Mine Number: C/015/015

Inspector's Statement

RE: ACT/015/015
CONSOL-Emery Mine

NOV 83-4-11-2, 2062

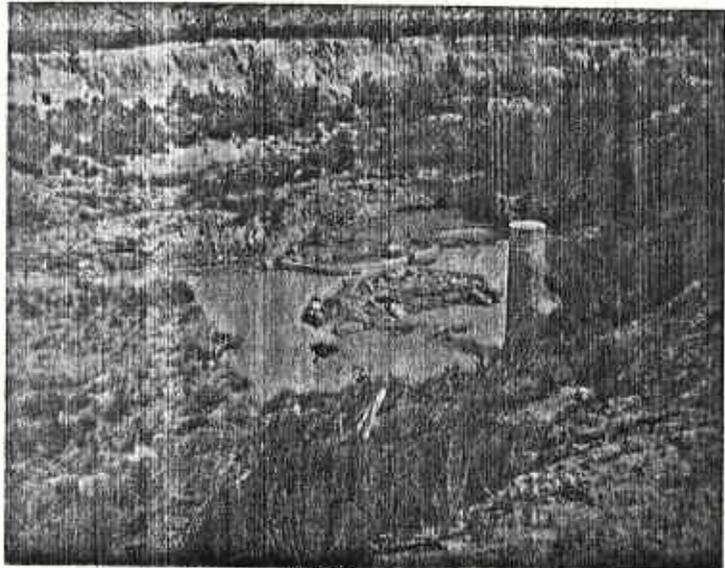
THE EVENT HAS OCCURRED SEVERE EROSION HAS OCCURRED ERODING THE STREAM BANKS AND CHANGING THE STREAM CHANNEL SO THAT IT CAN BYPASS THE TWO FOOT PERMANENT FLUME.

SEE ATTACHED PICTURE

SEVERAL HUNDRED CUBIC YARDS OF MATERIAL HAVE BEEN ERODED AWAY CONTRIBUTING ADDITIONAL SUSPENDED SOLIDS TO QUITEQUIAN CK. DAMAGE DOES EXTEND OFF THE PERMIT AREA.

EMERY DEED MINE 6/29/83 FLOWING SITE BELOW

CONFLUENCE OF CHRISTIANSEN WASH & BUTCHMAN CREEK

NOV 83-4-11-2, 2062

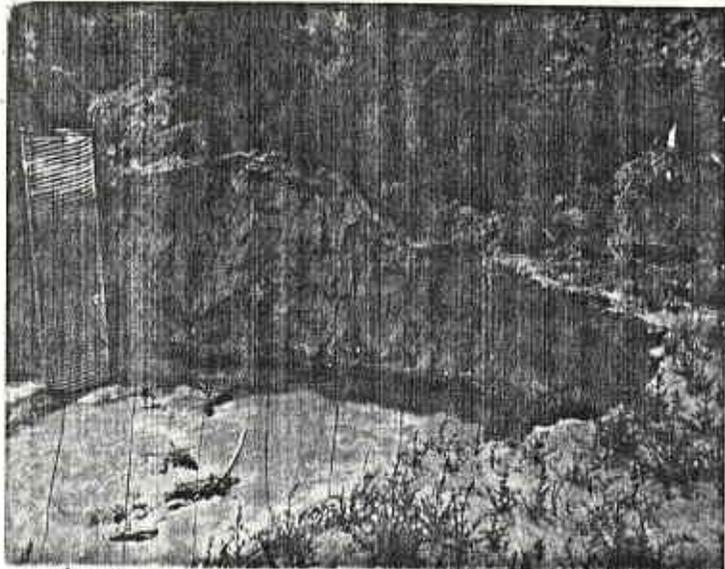
EMERY DEED MINE 6/29/83 FLOWING SITE BELOW CHRISTIANSEN

WASH - BUTCHMAN CR. CONFLUENCE. NOTE: THIS ENTIRE AREA HAS BEEN FLOODED SINCE FROM THE BOTTOM OF THE MINE - TOP OF BANK
